ROUNDEL HOMES INC. (PH-2)

PROJ. No. 23-01

LOT No. 40

PRAIRIE ROSE DRIVE

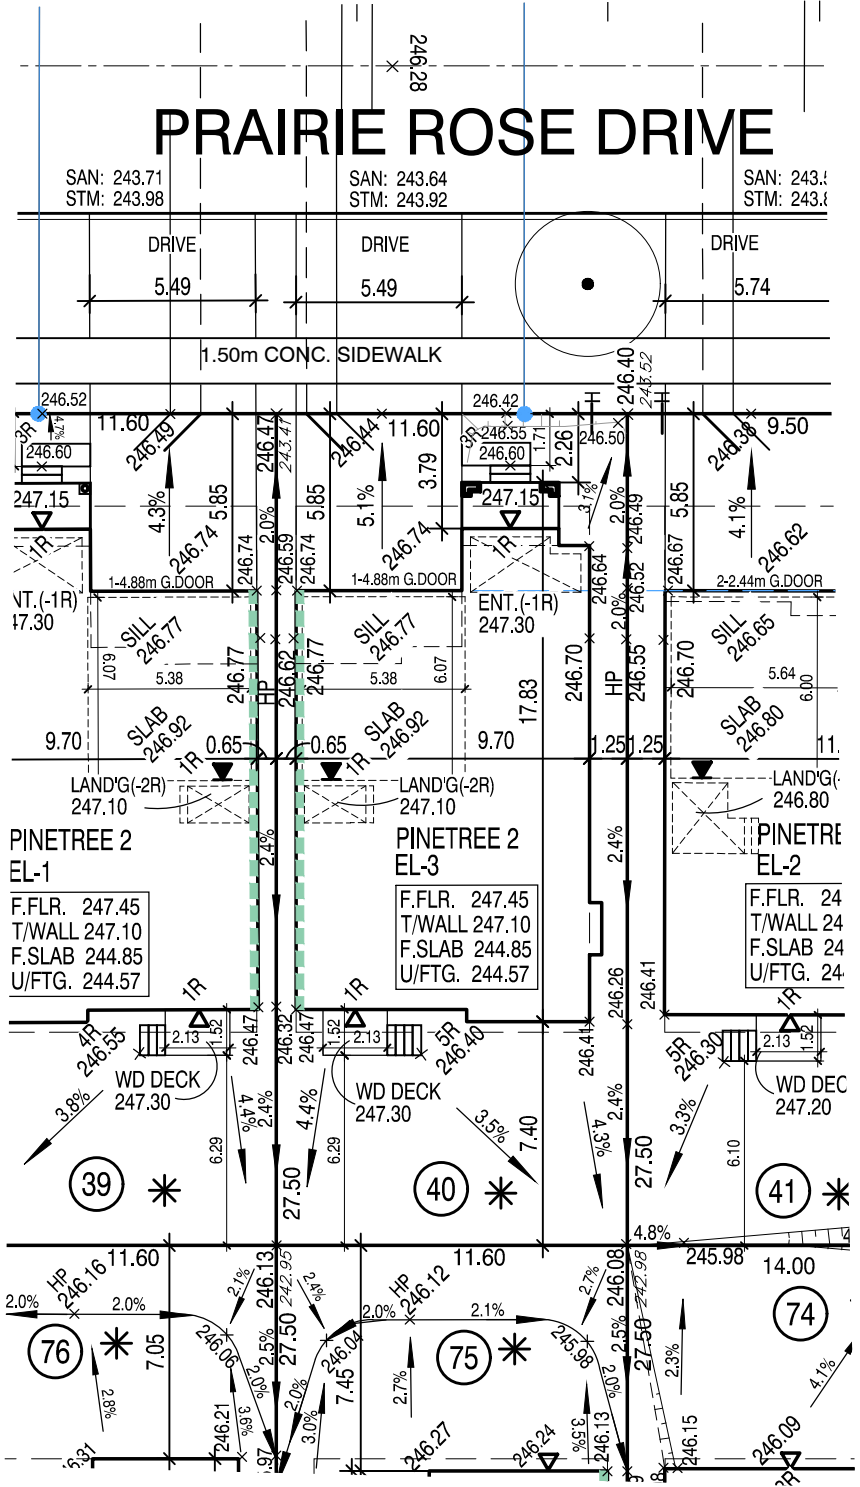
No unprotected openings permitted within 1.2 metres of the lot line as per 9.10.14 of the Ontario Building Code.

45 MINUTE RATED WALL WITH SIDE YARD < 1.2m
